League City South Shore Harbour Booster Pump Station Improvements

CDM Smith
Contractor Change Request

CONTRACTOR CHANGE REQUEST SUMMARY
 CITY OF LEAGUE CITY, TX
 SOUTH SHORE HARBOUR BOOSTER PUMP STATION IMPROVEMENTS PROJECT

Contractor Change Request No. 1

Drawing:	Well Construction		
Customer:	City of League City	Job No.:	1540
Project:	South Shore Harbour Well	By:	MSW
		Date:	12/18/2014

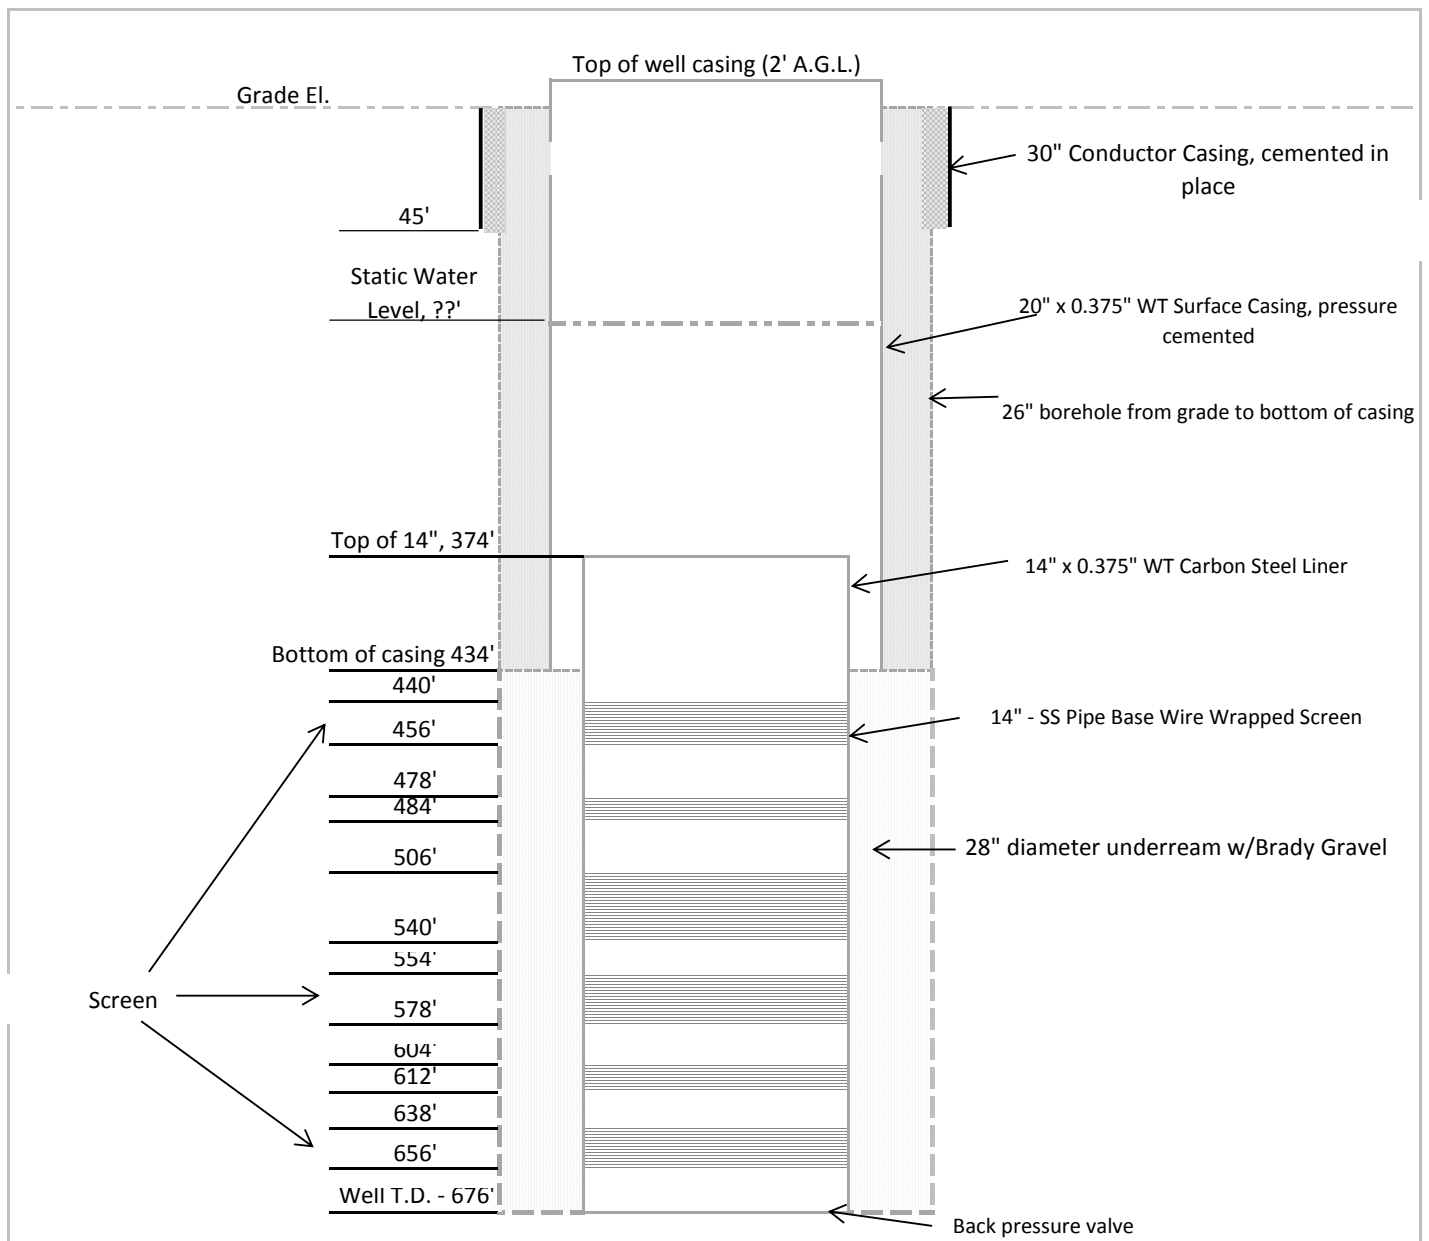
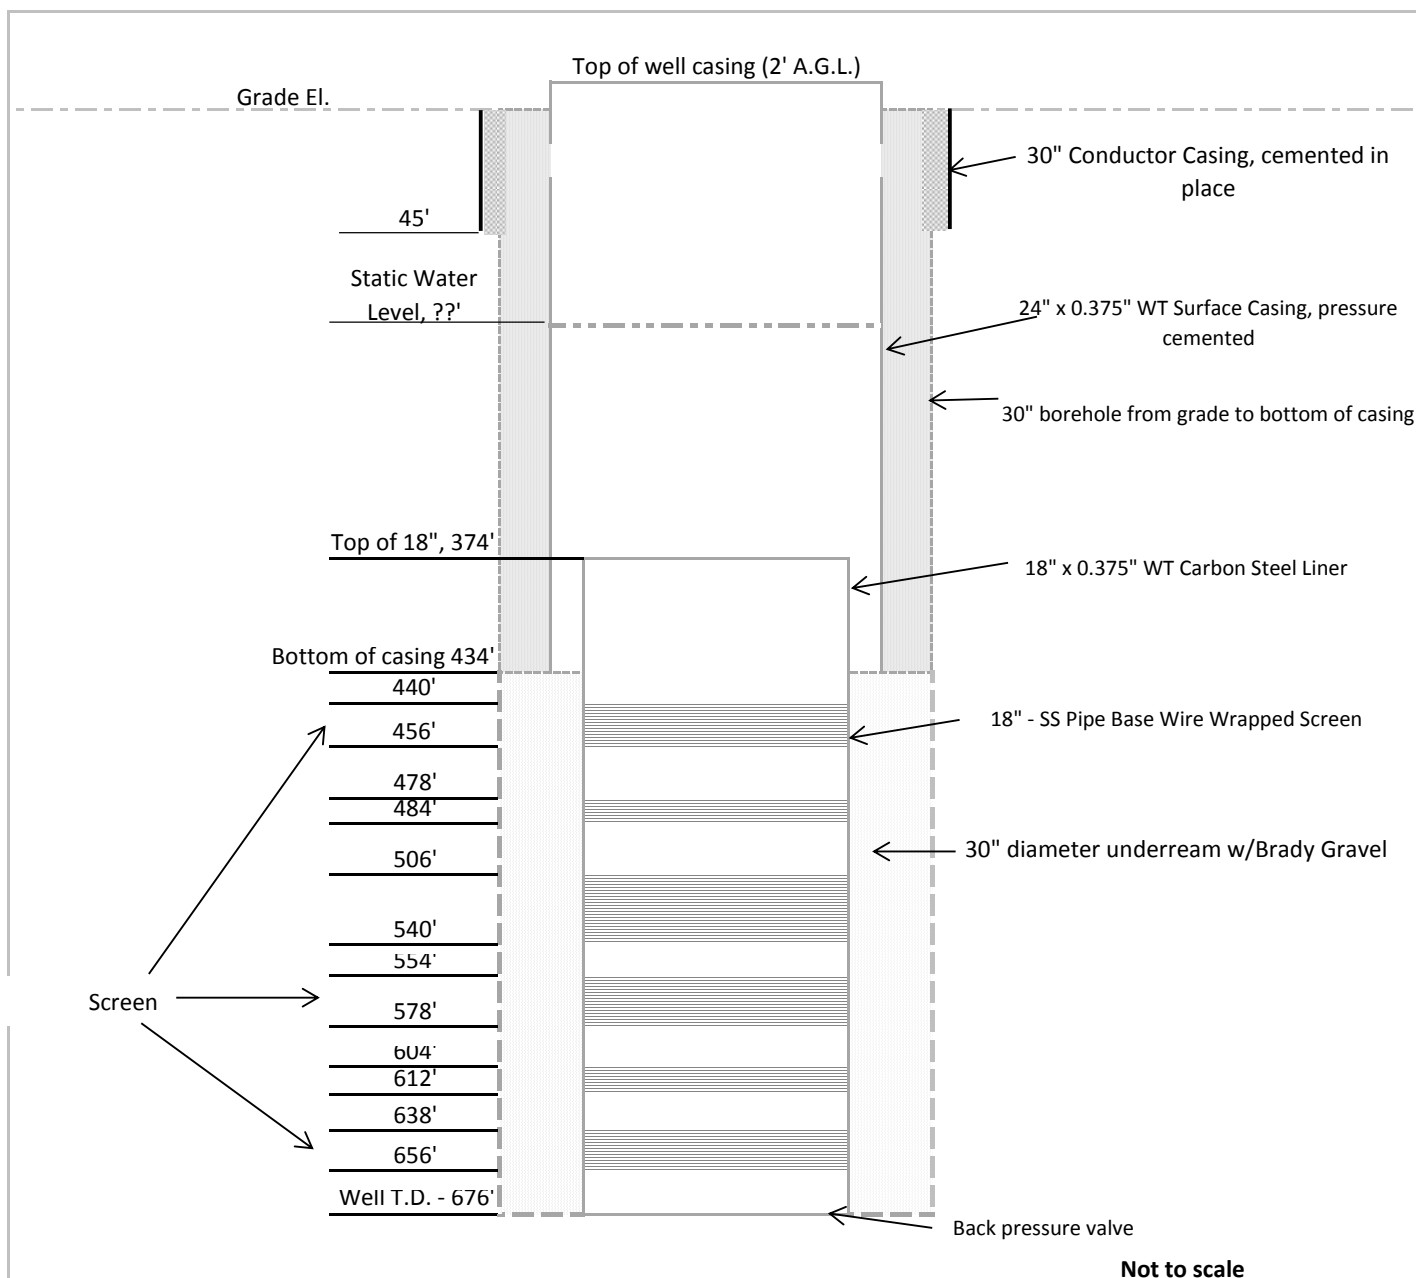
700 ft. – Pilot Hole Depth (no change)	\$0.00
434 ft. - 24" Surface Casing (Add 434 ft. @ \$125/ft.)	\$54,250.00
196 ft. - 18" Blank Liner (Add 196 ft. @ \$75/ft.)	\$14,700.00
106 ft. - 18" Pipe Base Screen (Add 106 ft. @ \$215/ft.)	\$22,970.00
0 ft. - 20" Surface Casing (Deduct 490 ft. @ \$85/ft.)	<\$41,650.00>
0 ft. - 14" Blank Liner (Deduct 74 ft. @ \$50/ft.)	<\$3,700.00>
0 ft. - 14" Pipe Base Screen (Deduct 136 ft. @ \$150/ft.)	<\$20,400.00>
Net Increase to Current Contract Amount	<u>\$26,170.00</u>
Revised Total Contract Amount	\$961,670.00

700 ft. – Pilot Hole Depth (no change)	\$0.00
434 ft. - 20" Surface Casing (Deduct 56 ft. @ \$85/ft.)	<\$4,760.00>
196 ft. - 14" Blank Liner (Add 122 ft. @ \$50/ft.)	\$6,100.00
106 ft. - 14" Pipe Base Screen (Deduct 30 ft. @ \$150/ft.)	<\$4,500.00>
Net Decrease to Current Contract Amount	<\$3,160.00>
Revised Total Contract Amount	\$932,340.00
